Local Powering of the Corrector Package in the Inner Triplet

An ECR presented to HL-LHC TCC on September 20 2018 proposes to remove the cold powering equipment related to these circuits replacing them by warm cabling from the converters location to LHC-type conduction-cooled current leads integrated in the CP magnet cryostat.

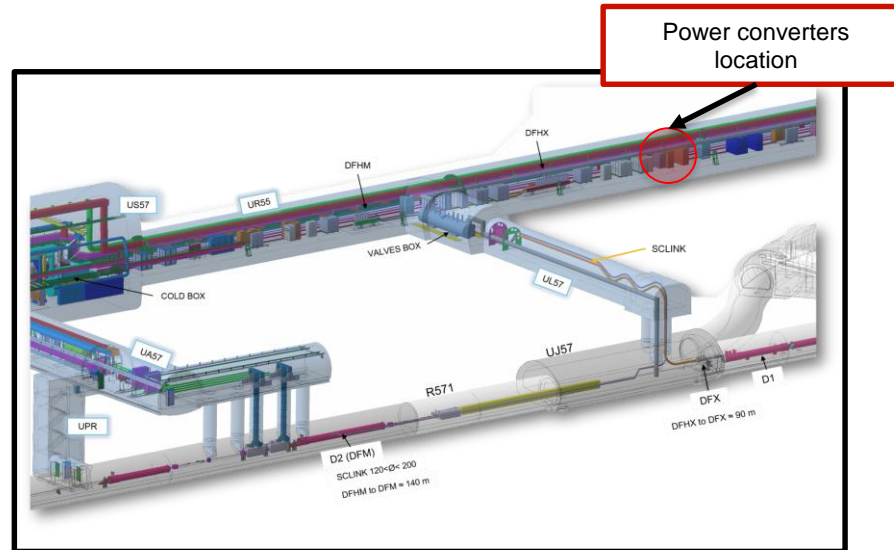
The HL-LHC Cold Powering baseline envisaged powering the Inner Triplet Corrector Package (CP) circuits rated at 200 A and below via the MgB_2 Superconducting Link and associated cryo-electrical equipment.

Case B (P5)

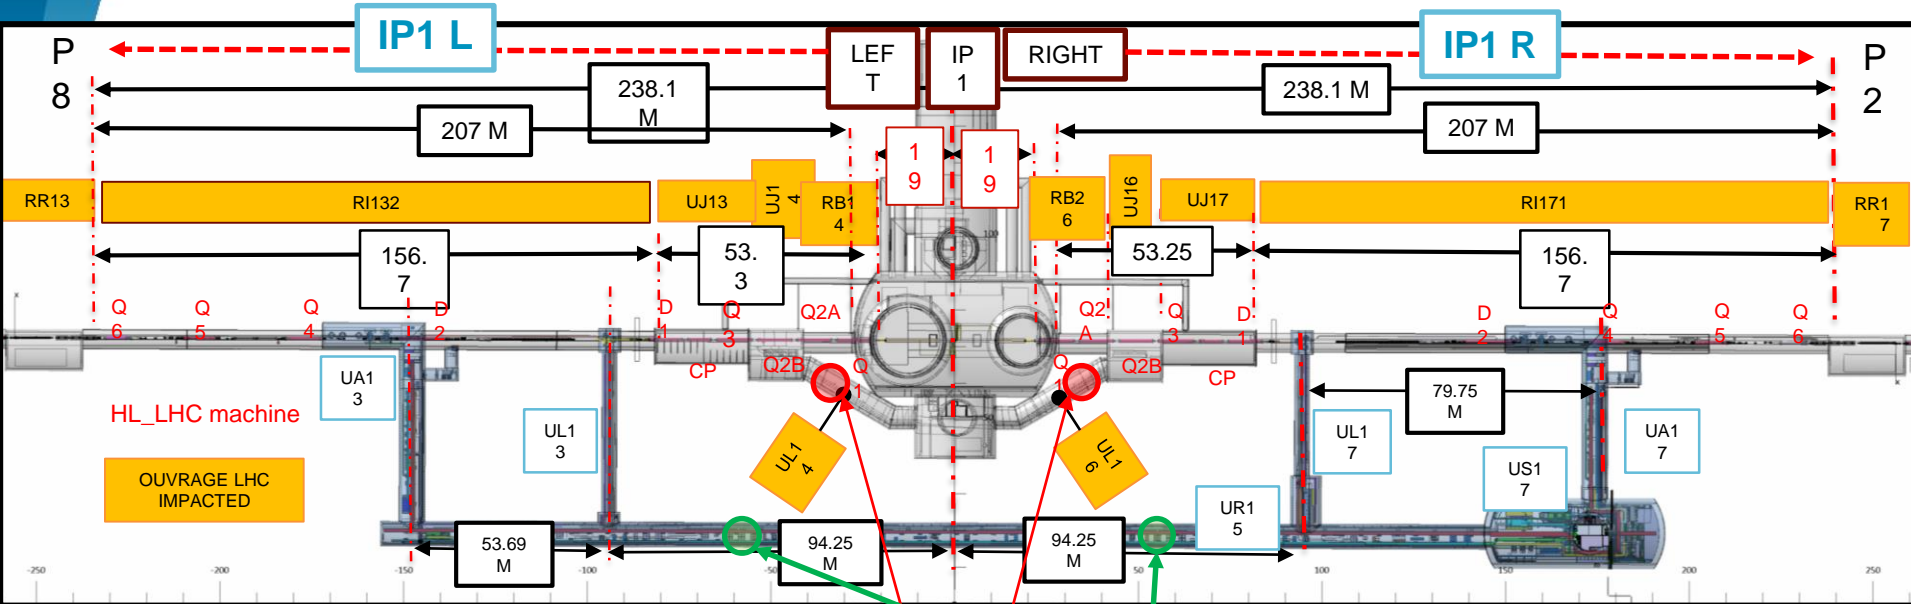
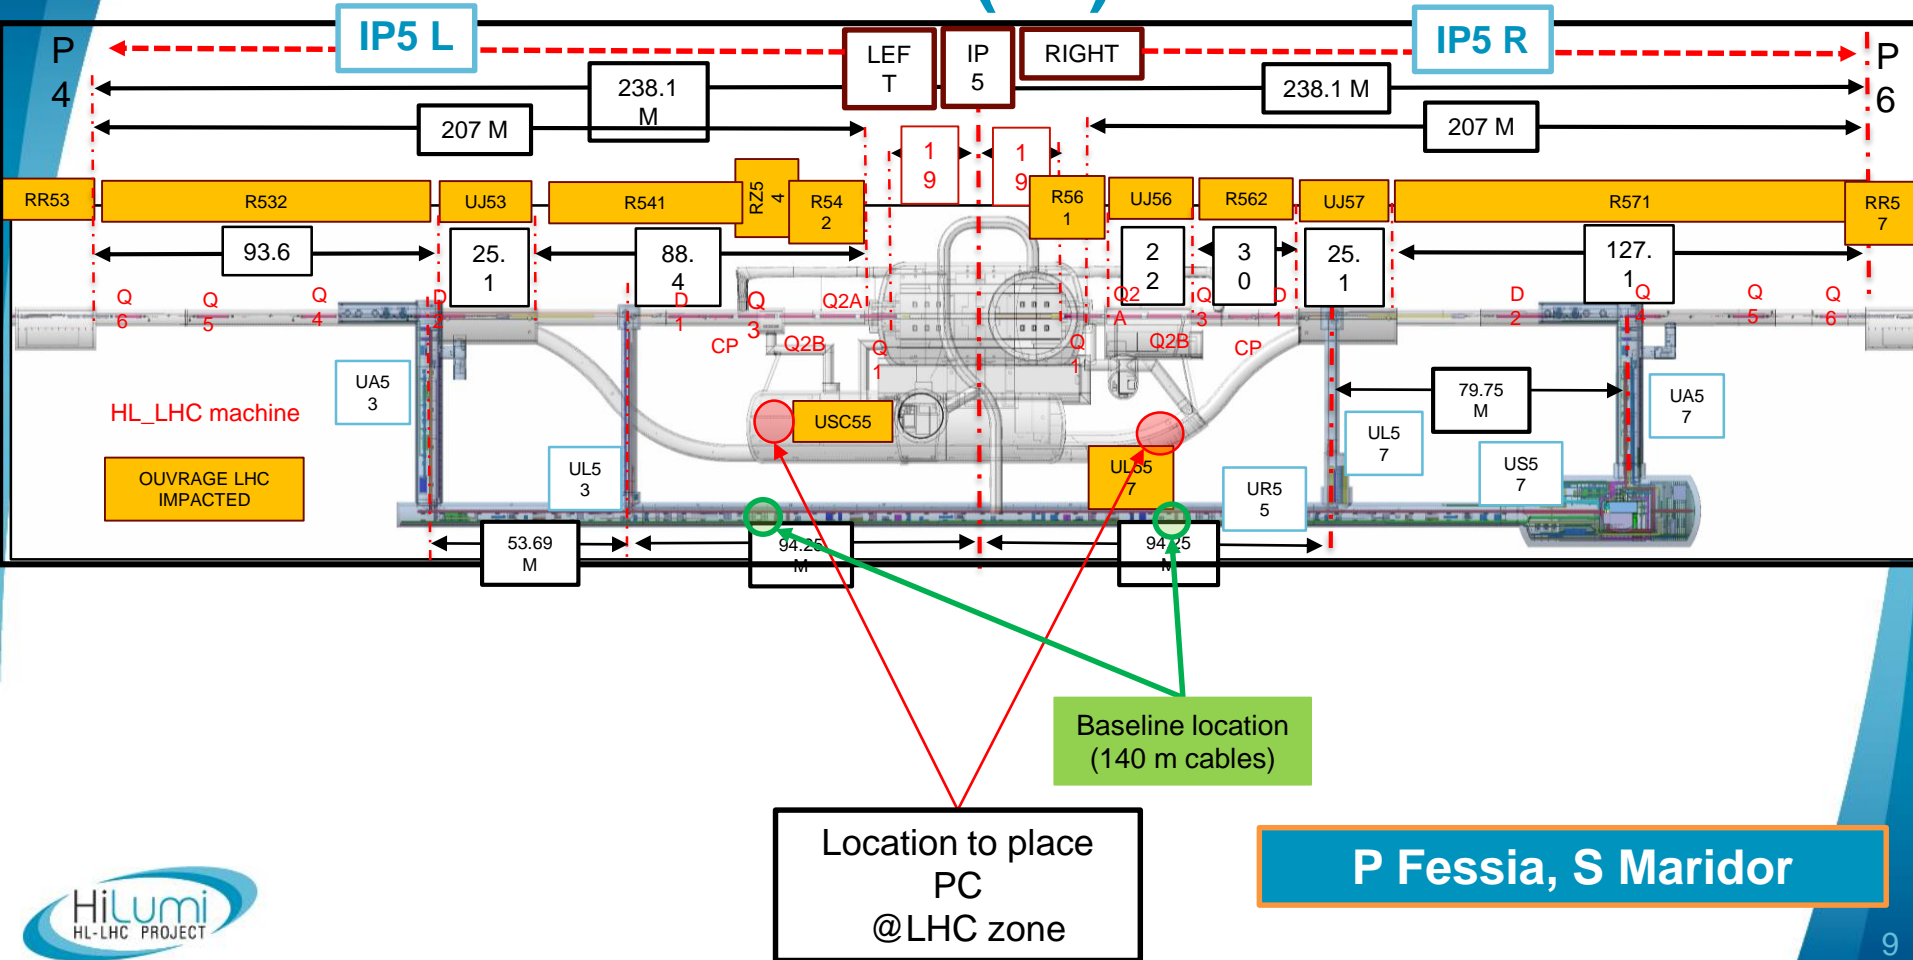
- either leaving the concerned power converters in the present baseline location, i.e. in the UR (case A),***
- or by re-locating the power converters in the **LHC's** UL14, UL16, UL557 and USC55 (case B).***

3 racks PC 120 A
(R2E design) , (8 pc).

1 rack PC 200 A
(R2E-LHC600A-10V)

¼ rack energie
extraction
for 200A → 1 rack

1 rack spare
contrôle
(RYSC01)

2 racks spare
modules
(RYSA01-RYSA02)
